CV6052
CV6053
CV6054

MINISTRY OF AVIATION, DLRD/RRE.

Specification MOA/CV6052-4 Issue 2A, Dated 12th December 1963 To be read in connection with K1006.	<u>SECURITY</u>	
	<u>SPECIFICATION</u> UNCLASSIFIED (See Note 13)	<u>VALVE</u> UNCLASSIFIED

ELECTRONIC VALVE SPECIFICATIONS
SPECIFICATION MOA/CV6052-4 ISSUE 2A DATED
12th December, 1963
AMENDMENT No. 1

DRAWING NOTES

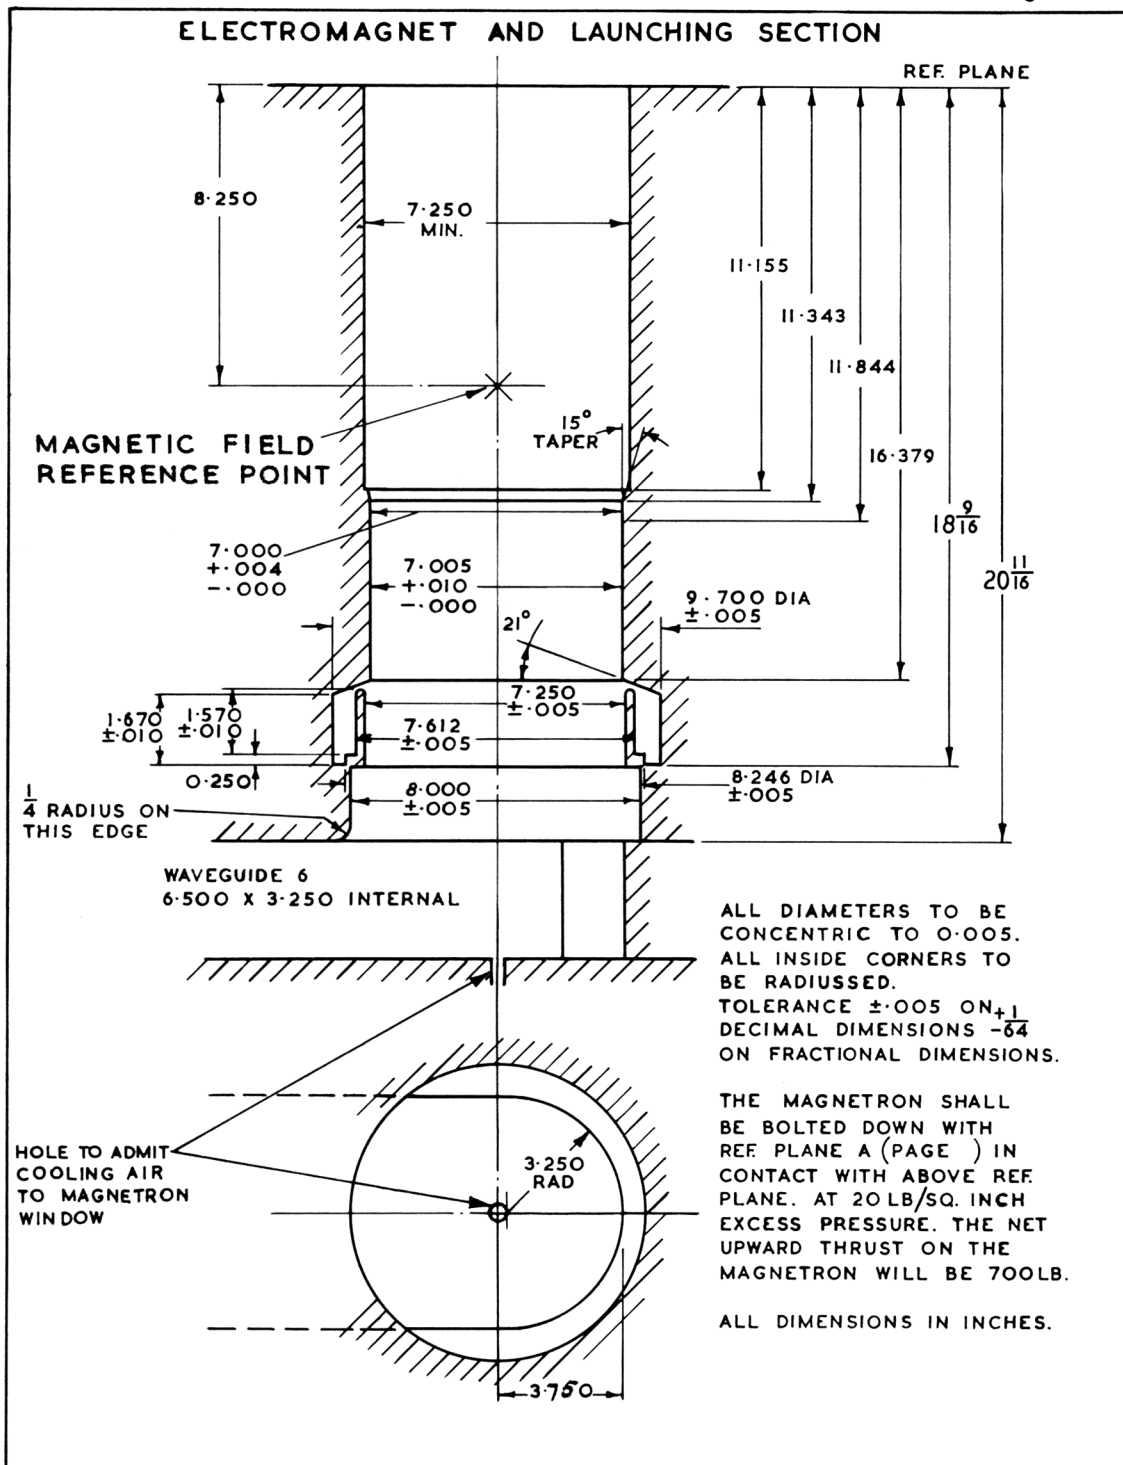
Page 7 Drawing Notes

Delete existing Note 5 and substitute. "The U.K. NATO Stock No. for the Heater Cathode Coaxial socket is 5960-99-932-5870.

The U.K. NATO Stock No. for the free plug mating with the above socket is 5960-99-940-1839.

5. Heater Cathode Coaxial Connector:- ~~The Joint Services Cat. No is 5935-99-940-1839~~ See also drg on page 11. *Amult.1*
6. Bush threaded 1-12 UNF-2B (American thread). Brass Silver plated.

5. The U.K. NATO Stock No for the Heater Cathode Coaxial Socket is 5960-99-932-5870

The U.K. NATO Stock No. for the free plug mating with the above socket is 5960-99-940-1839. *Amult.1*

Page 6, Note 3, add the following:-

"(Ring, Sealing, Toroidal, NATO Stock No. 5330-99-954-
8782)"

1. Reference Plane A.
2. 8 Holes $0.312 \pm .004$ Dia. Spacing and P.C.D. to suit gauge.
3. 'O' Sealing Ring 6.475 I/Dia : 0.275 Section Diameter 0.S.67 (B.S.1806:1951).
Neoprene Rubber - 60° Shore. *Ring, Sealing, Toroidal, NATO Stock No 5330-99-954-8782*
